Ortho Imagery QA/QC Report Form

Project Name: Sacramento 15cm Lot 4 State: CA
Date Received: 10/4/11, 11/8/11 Date Review Completed: 10/6/11, 11/9/11
Reviewer(s): Dale Benson Contract Type: GPSC
Primary Contractor: Woolpert

Error 03 Building lean covers streets (Accepted AS-IS)

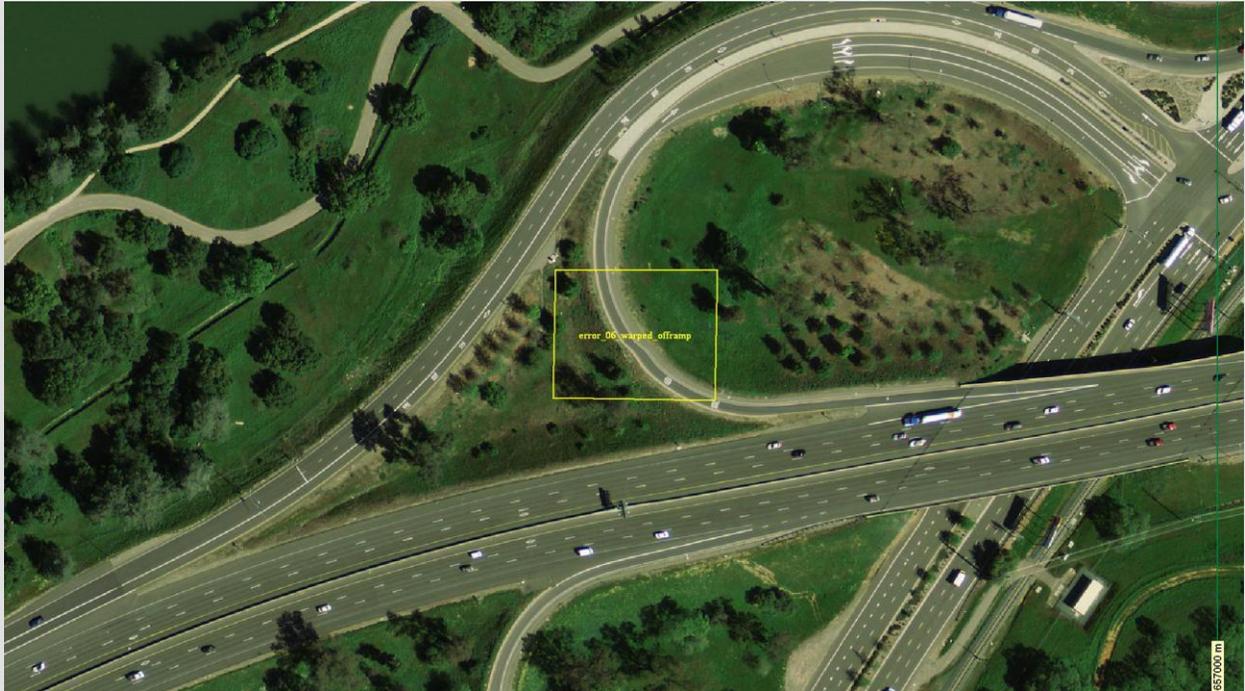
Error 02 Warped Roadway at end of Bridge (Fixed)

Error 04 Building lean covers streets (Accepted AS-IS)

Error 05 Building lean covers streets *(Accepted AS-IS)*

Error 07 Offset tracks and roadway beneath overpasses (Fixed)

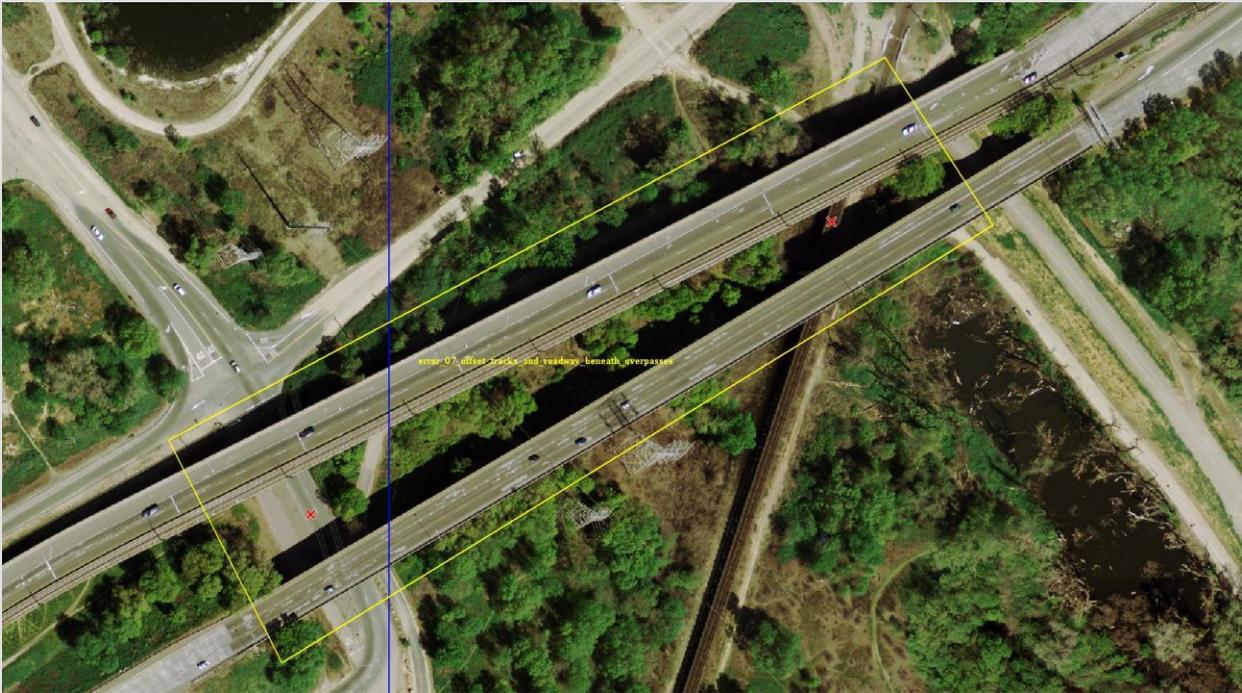
Error 06 Warped offramp *(Not in 15cm Dataset)*

Error 08 Warped railroad tracks (Fixed)

Error 09 Offset roadway beneath overpasses (*Fixed*)
